JOINT REGIONAL PLANNING PANEL (East)

JRPP No	2016SYE013
DA Number	239/13/4
Local Government Area	North Sydney Council
Proposed Development	Section 96(2) application to modify consent for demolition of existing structures and the construction of a mixed use development comprising basement levels, commercial floor space, and residential apartments involving modifications and increase in apartment numbers from 218 to 232.
Street Address	144-154 Pacific Highway and 18 Berry Street North Sydney
Applicant/Owner	Fu Ji (North Sydney) Pty Ltd
Number of Submissions	Two
Regional Development Criteria (Schedule 4A of the Act)	Section 96(2) Modification application of Capital Investment Value > \$20M
List of All Relevant s79C(1)(a) Matters	North Sydney LEP 2013 - Zoning – B4 Mixed Use North Sydney DCP 2013 S94 Contribution SEPP 55 - Contaminated Lands SREP (2005)
List all documents submitted with this report for the panel's consideration	Plans
Recommendation	Approval

Report by	Geoff Mossemeneer, Executive Planner, North Sydney Council

Figure 2 – Comparison of approved (left) sloped roof top glazing with proposed (right)
Source: AJ + C Architects

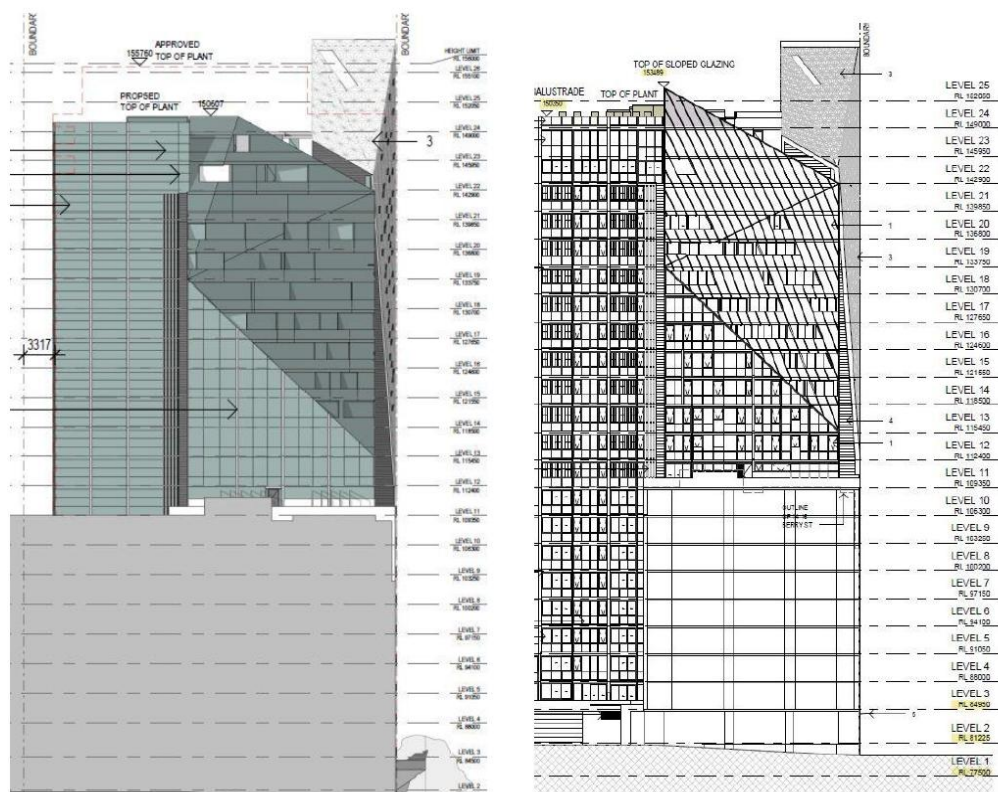
The proposed rooftop design and height of the building remains generally consistent with that of the approved development and will not result in any additional amenity impacts. The maximum height of the development approved under DA239/12/3 is RL158.49 when measured to the architectural roof feature. The proposed changes to the building's rooftop plant and angular façade do not increase the buildings maximum height and have been designed to retain the same angular slope as the approved development.

Figure 3 –Comparison of approved building height (left) with proposed (right)
Source: AJ + C Architects

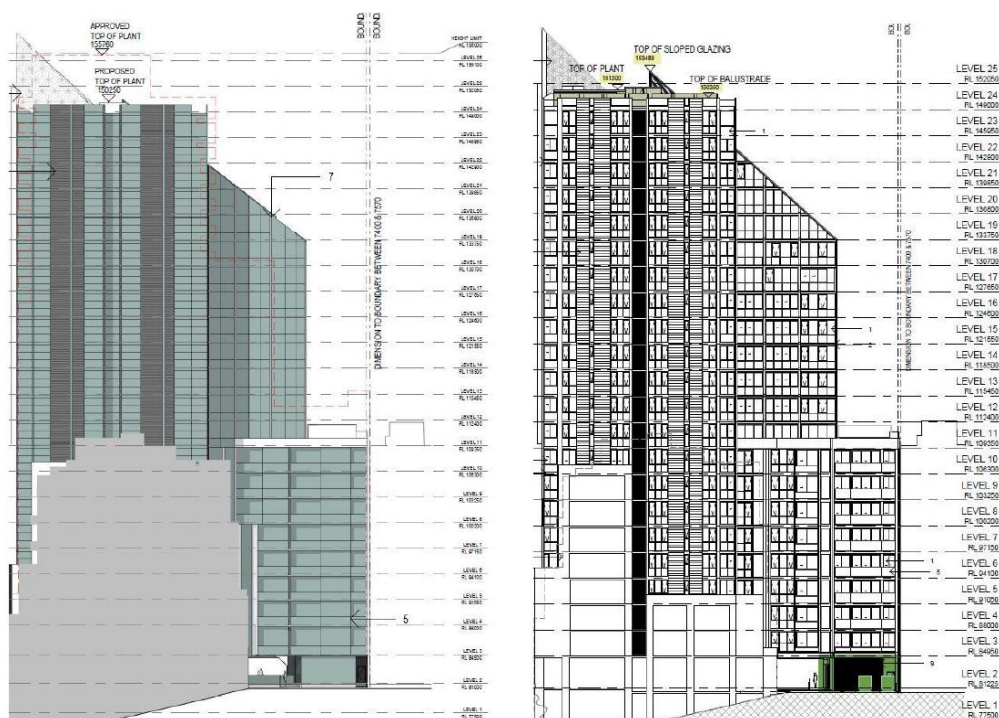
The inclusion of additional plant is not anticipated to reduce amenity. The height increase of the plant is minor and does not protrude beyond the highest point of the building. This combined with the fact the plant is recessed behind the building parapet will ensure that it is not visible from the street and will therefore not increase the perceived bulk and scale of the development.
